SUBJECT: Palisades Nuclear Plant Response to Request for Additional Information
for the Overall Integrated Plan in Response to the Commission Modifying
Licenses with Regard to Requirements for Reliable Spent Fuel Pool
Instrumentation

Palisades Nuclear Plant
Docket No. 50-255
License No. DPR-20

Palisades Nuclear Plant Spent Fuel Pool Instrumentation Order Request for Additional Information (RAI) Responses

Figure 1, SFP Elevation View with Levels Indicated

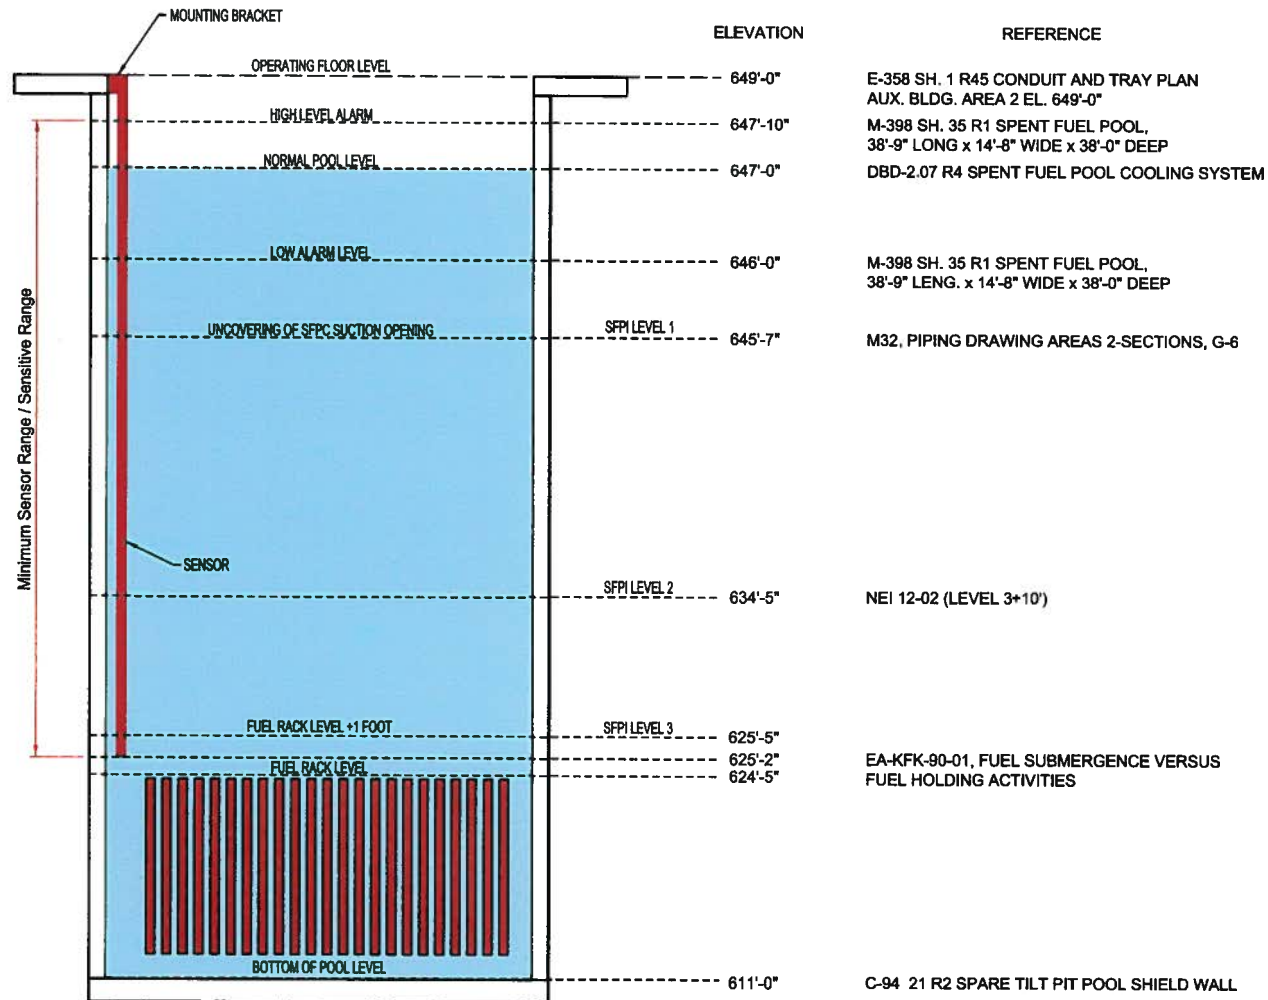
- b) A clearly labeled sketch depicting the elevation view of the proposed typical mounting arrangement for the portions of instrument channel consisting of permanent measurement channel equipment (e.g., fixed level sensors and/or stilling wells, and mounting brackets). Indicate on this sketch the datum values representing Level 1, Level 2, and Level 3 as well as the top of the fuel racks. Indicate on this sketch the portion of the level sensor measurement range that is sensitive to measurement of the fuel pool level, with respect to the Level 1, Level 2, and Level 3 datum points.*

- a) The water level above the pump necessary to maintain the required net positive suction head (NPSH) for saturated conditions is approximately 605'. This level is well below 645'-7", which is the level at which the cooling pump suction pipe begins to uncover. Therefore, the Level 1 elevation is 645'-7".*
- b) The requested information is provided in Figure 1. The figures indicate Levels 1, 2, and 3 as well as the approximate location of the proposed mounting bracket incorporating the Seismic Category I attachment. The sensor is a perforated tubular coaxial waveguide that provides continuous level measurement axially and is sensitive over its entire length. These sketches apply to both the primary and backup channels.*

The spent fuel pool (SFP) level lower instrument span or probe bottom extends down to at least three inches below the upper limit of the range of Level 3 to account for channel accuracy or instrument loop uncertainty. Therefore, the SFP level probe bottom/span extends down to at least elevation 625'-2" (see Figure 1). The SFP level upper instrument span, at a minimum, includes the high level alarm. Note that Level 3 is shown in accordance with Nuclear Energy Institute (NEI) 12-02, "Industry Guidance for Compliance with NRC Order EA-12-051, 'To Modify Licenses with Regard to Reliable Spent Fuel Pool Instrumentation,'" Revision 1, guidance relative to the top of the rack; the top of the fuel is not shown.

Figure 2, Plan View of the Spent Fuel Pool Area

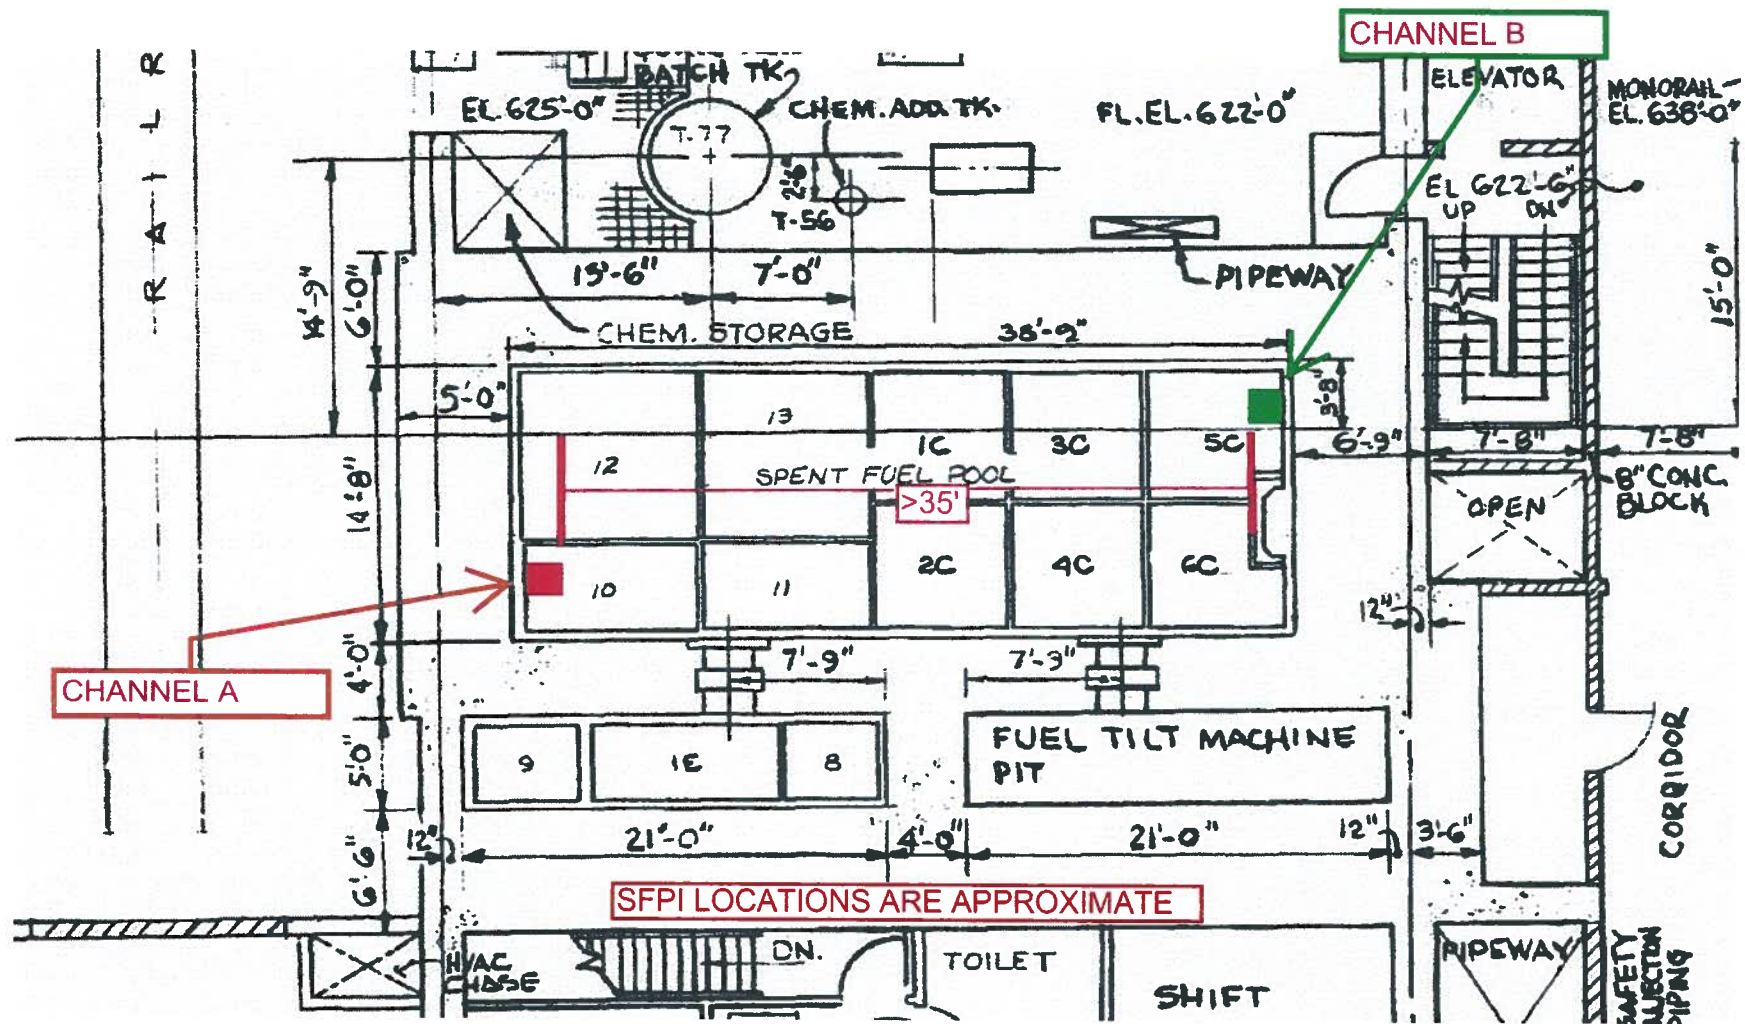
Please clarify the sketch or marked-up plant drawing of the plan view of the SFP area that you submitted in Attachment 1, to depict the SFP inside dimensions in a more readable manner.

Figure 2 shows the inside dimensions as requested.

Figure 3, Level Probe

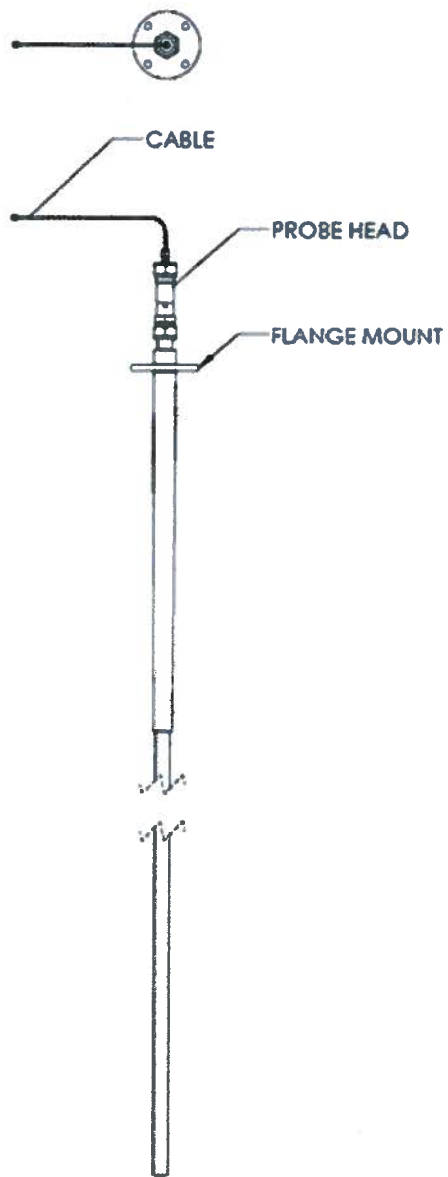
- b) *A description of the manner in which the level sensor (and stilling well, if appropriate) will be attached to the refueling floor and/or other support structures for each planned point of attachment of the probe assembly. Indicate in a schematic the portions of the level sensor that will serve as points of attachment for mechanical/mounting or electrical connections.*

- b) The proximal portion of the level probe is designed to be attached near its upper end (refer to Figure 3) to a Seismic Category I mounting bracket configured to suit the requirements of a particular SFP. The bracket may be bolted and/or welded to the SFP deck and/or SFP liner/wall according to the requirements of the particular installation per Seismic Category I requirements.
- c) See (b) response above.
- d) An evaluation of non-special nuclear material inventory located in the SFP will be performed during the spent fuel pool instrumentation (SFPI) modification process. Non-special nuclear material access to the SFP is governed by EN-RE-220, "PWR Control of Miscellaneous Material in the Spent Fuel Pool." This procedure will be used to prevent any instrument interference from non-special nuclear materials.
